**CITY OF VESTAVIA HILLS
SICARD HOLLOW ATHLETIC COMPLEX- PARK IMPROV. PHASE 3
VESTAVIA HILLS, ALABAMA**

HNP C019005

5 August 2019
ADDENDUM NO. 2
Specifications of the Contract Documents
City of Vestavia Hills
Sicard Hollow Athletic Complex - Park Improvements Phase III

FUTSAL/PICKLEBALL COURT PAVING

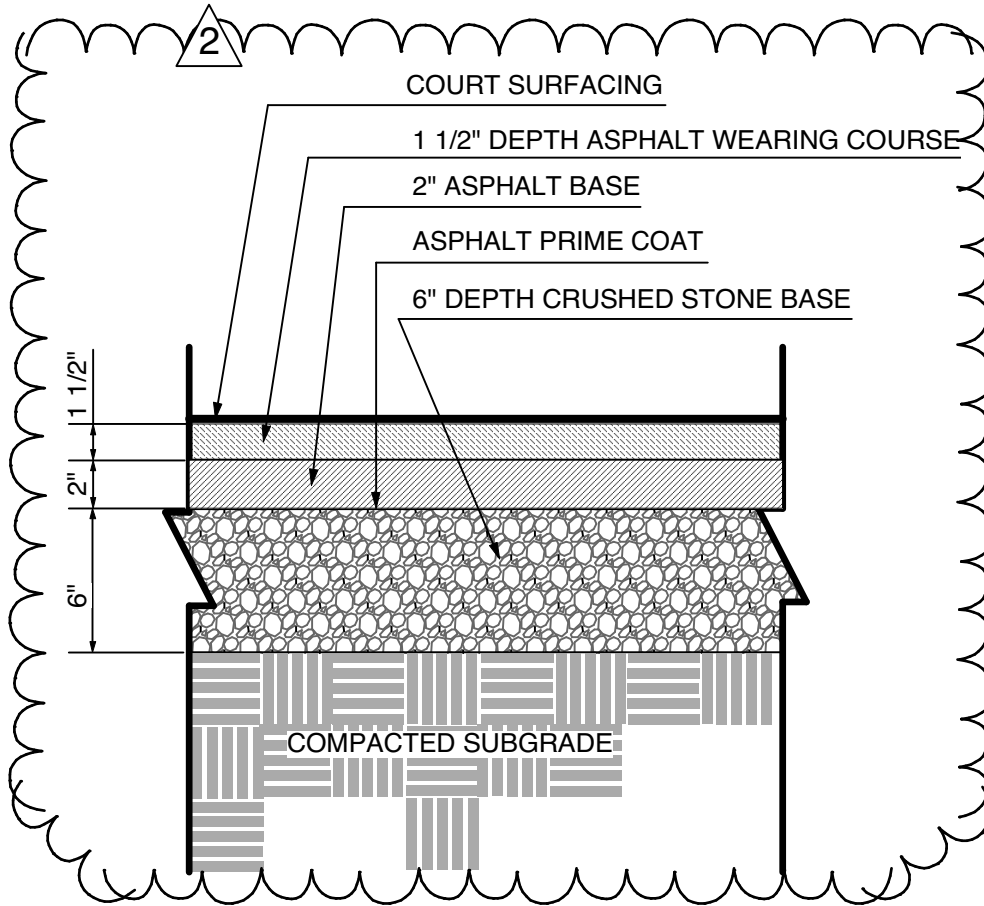
1. Replace **Detail 4** Titled: **FUTSAL/PICKLEBALL COURT PAVING** with the detail attached to this Addendum.
2. Add the following Note to **Detail 1** Titled: **FUTSAL LAYOUT PLAN:**
